|  | <b>EPC FOR UPGRADATION OF FACILITIES AT SE FIELD</b> |                      |                                                                                                                           |                                                                                                                                                                                                       |
|                                                                                  | <b>COMMENTS RESOLUTION SHEET (CRS)</b>               |                      |                                                                                                                           |                                                                                                                                                                                                                                                                                          |
| P29171-29-01-08-1601                                                             | C                                                    | ATC-4700022908-00770 | <b>PIPING AND INSTRUMENT DIAGRAM</b><br><b>DISPOSAL WATER: P

DRG. TITLE:  
**PIPING AND INSTRUMENT DIAGRAM  
DISPOSAL WATER : P-2415, 2416 & 2417  
CDS : SHAH (CONSTRUCTION)**

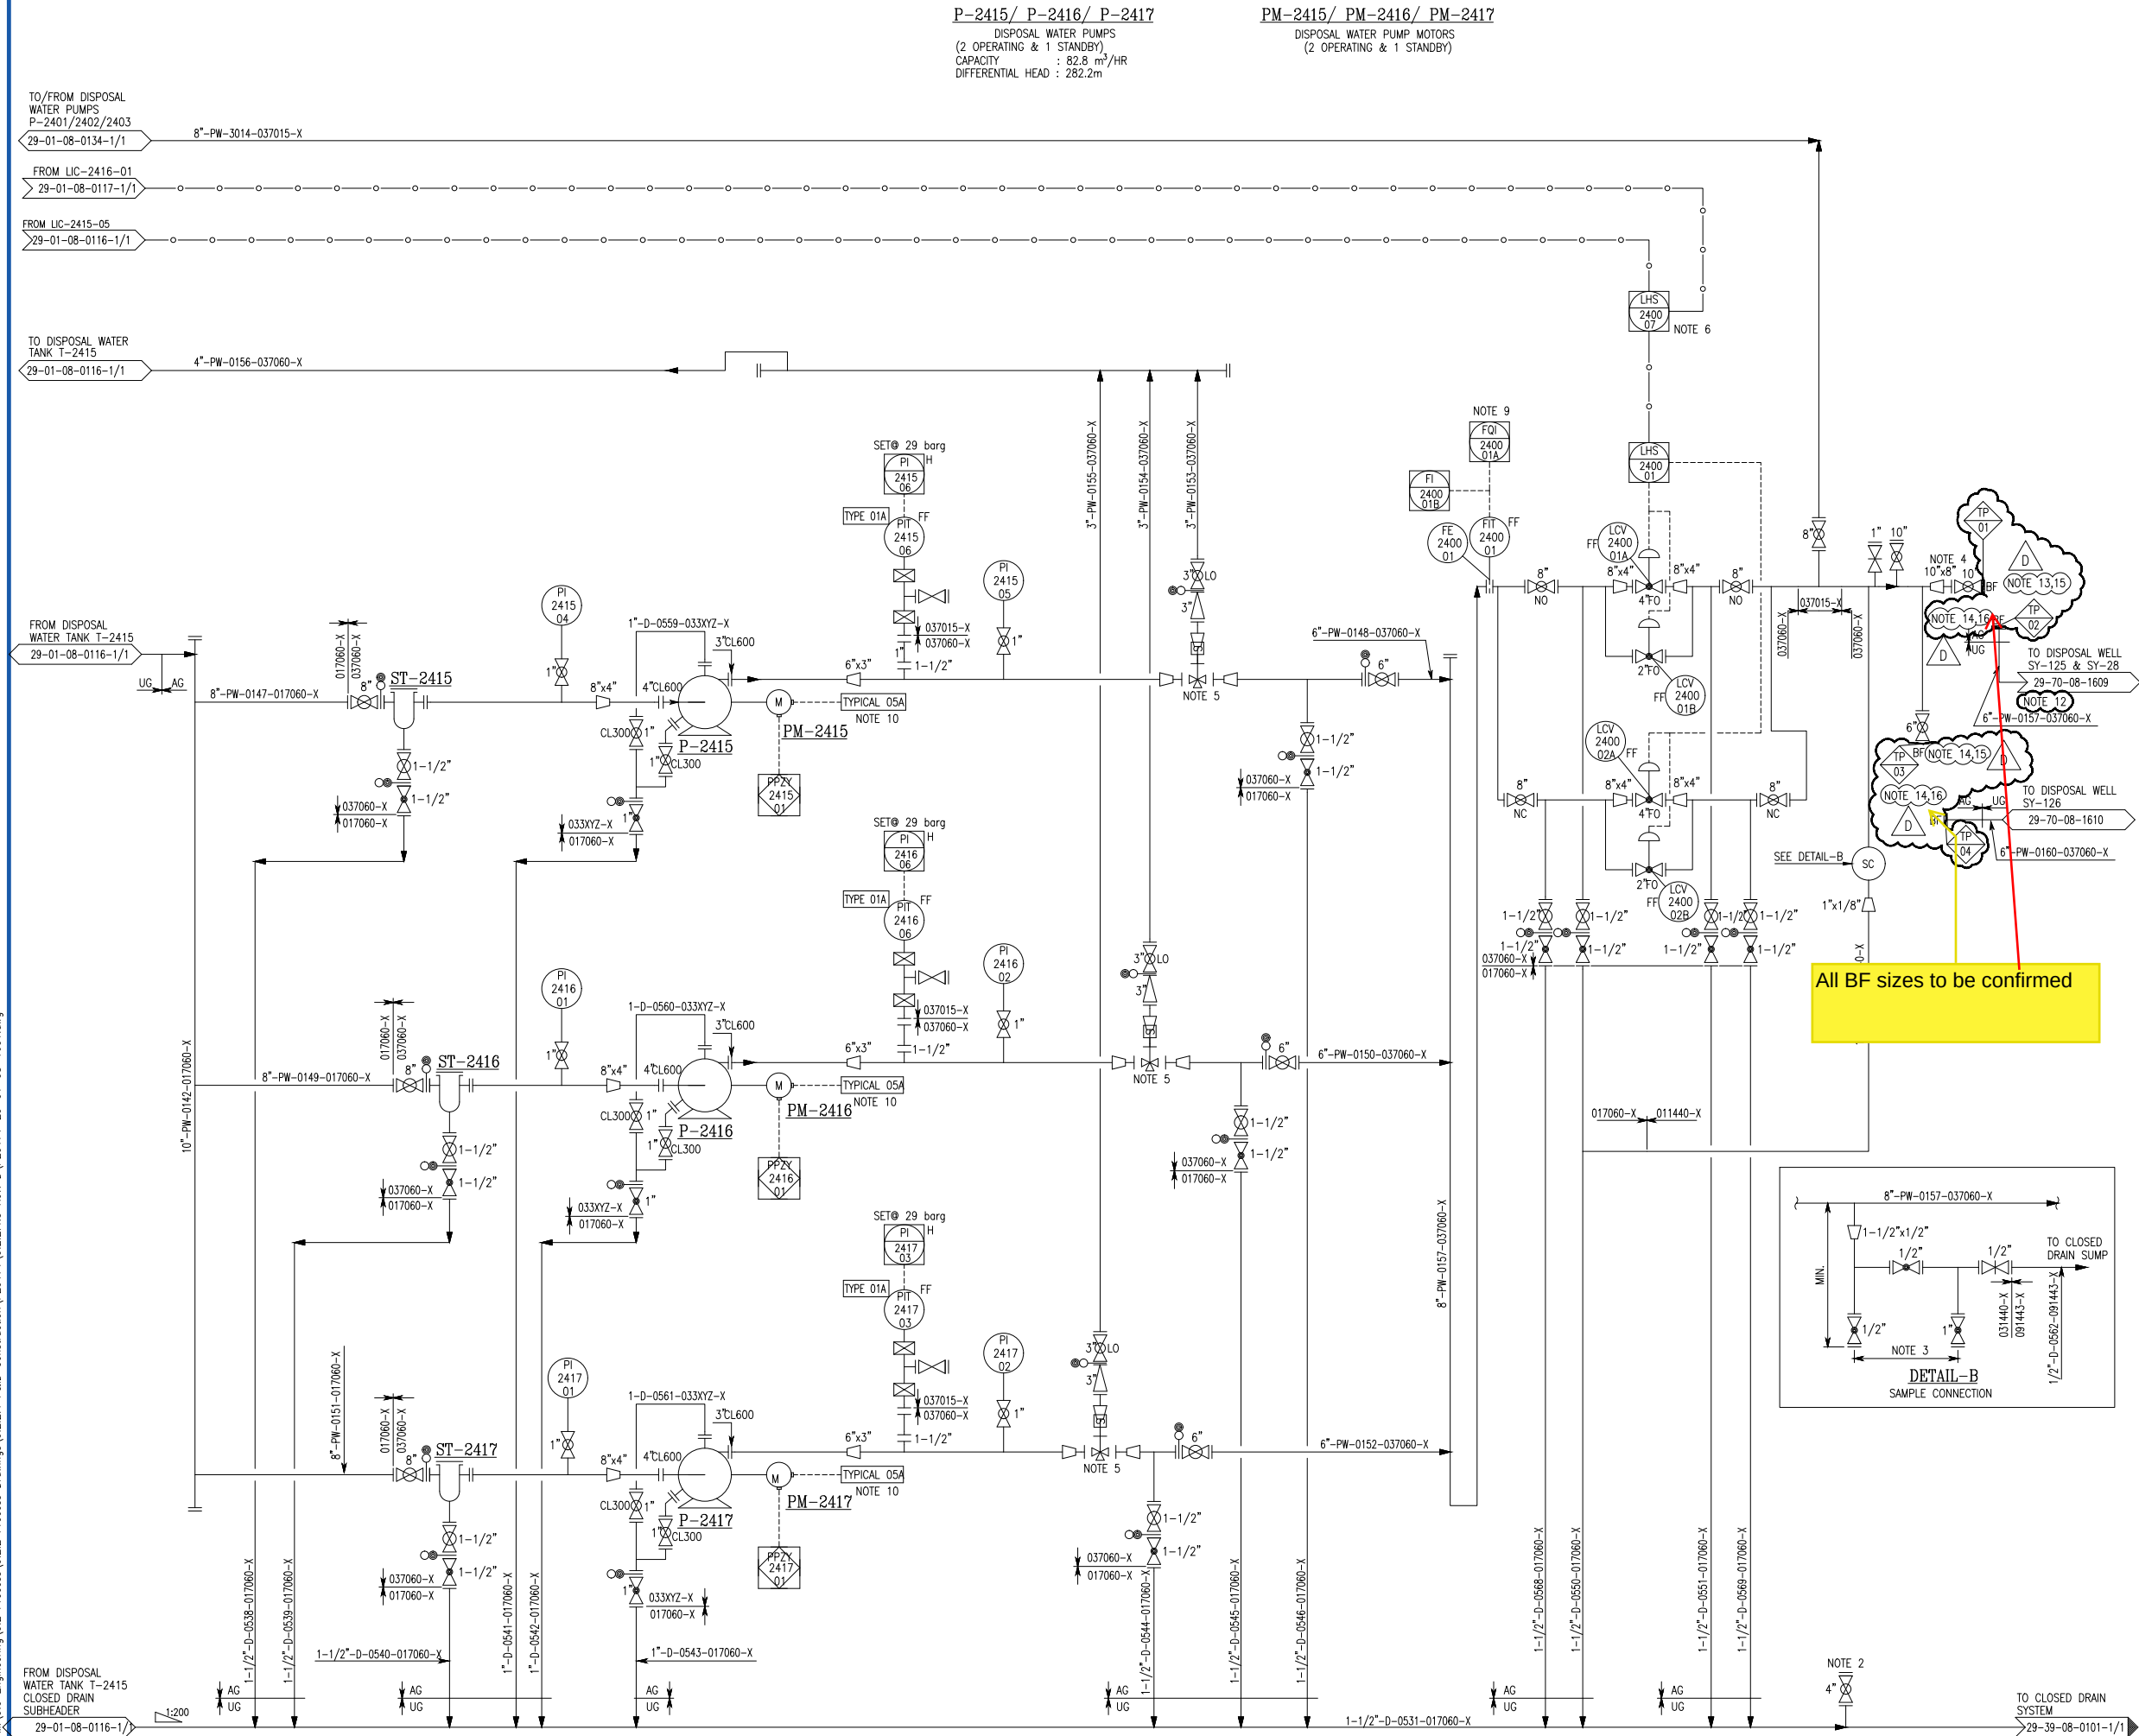
| S. No. | Reference / Page No. | COMPANY Comments                                                                                 | CONTRACTOR Response                                                                    | Status / Remarks                                                                      |
|--------|----------------------|--------------------------------------------------------------------------------------------------|----------------------------------------------------------------------------------------|---------------------------------------------------------------------------------------|
| 1.     | P29171-29-01-08-1601 | Add the note on the P&ID for reference.                                                          | Note-12 has been incorporated as per existing site conditions.                         |                                                                                       |
| 2.     | P29171-29-01-08-1601 | Blind flange size to be confirmed.                                                               | Blind Size has been confirmed for all the flanges in Note-13 and Note-14 respectively. |                                                                                       |
| 3.     | P29171-29-01-08-1601 | Spec Breaks at flanges to indicate the blind flange material considering clarity for future use. | Note 15 and Note 16 are incorporated accordingly to confirm the Blind Flange material. |                                                                                       |

- LINE SIZE IS 6 INCHES AS PER EXISTING SITE CONDITIONS.
  - BLIND FLANGE SIZE SHALL BE 10 INCH AS PER THE LINE SIZE.
  - BLIND FLANGE SIZE SHALL BE 6 INCH AS PER THE LINE SIZE.

- THE BLIND FLANGE MATERIAL SHALL BE CARBON STEEL, SAME AS THE VALVE, AS PER THE SITE CONDITION.
  - THE BLIND FLANGE MATERIAL SHALL BE CARBON STEEL AS THE PIPING IS BEING ABANDONED.
